ALTERNATOR ASSEMBLY (P/N 69670-04)

04 → 4111810R

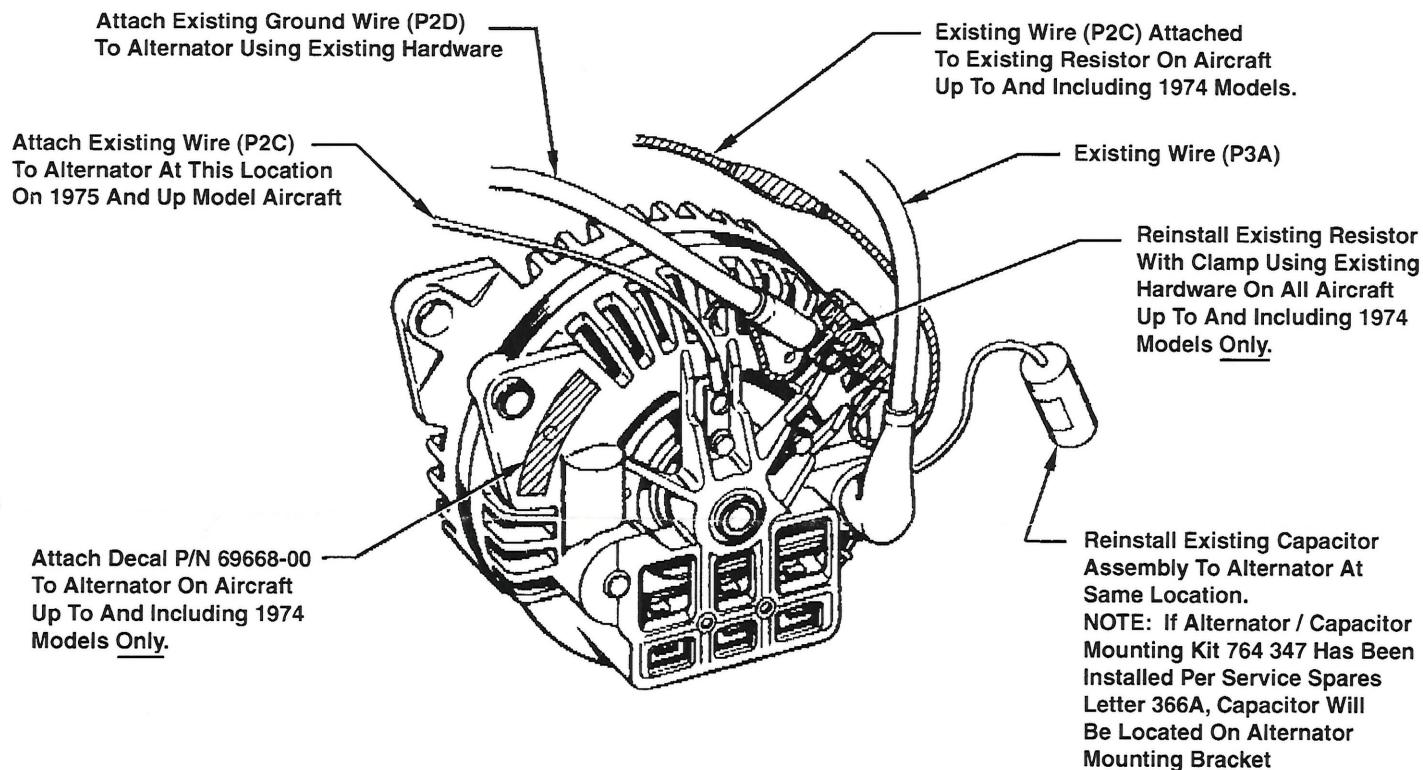
Alternator Assembly P/N 69670-04
Is Being Supplied As A Replacement For
Alternator Assemblies P/N 69670-00
And 69670-03 Which Are No
Longer Available. Refer To Sketches
Below For Proper Installation.

Alternator Mounting Bracket Rework Required
As Shown Below When Replacing Alternator Assembly
P/N 69670-00 Or 69670-03 With 69670-04. (4111810)
(3656624)
